Product Change Notification / CADA-13DJIO298

CCB 5156 Initial Notice: Qualification of C194 as an additional lead frame material for selected PIC24F16Kxx, PIC24F32Kxx, PIC24FV16Kxx and PIC24FV32Kxx device families available in 48L UQFN (6x6x0.5mm) package

CCB 5156
Pre and Post Change Summary
PCN #: CADA-13DJIO298

EFTEC64T

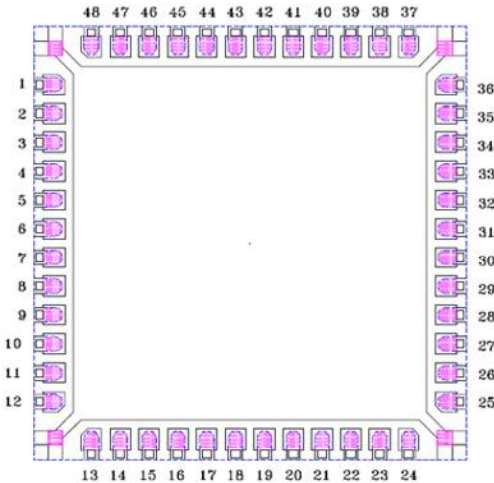
LEAD FRAME COMPARISON

Lead frame Paddle Size	193x193 mil

C194

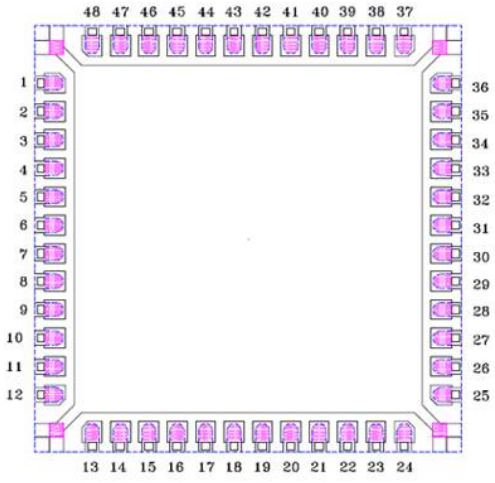
Lead frame Paddle Size	193x193 mil
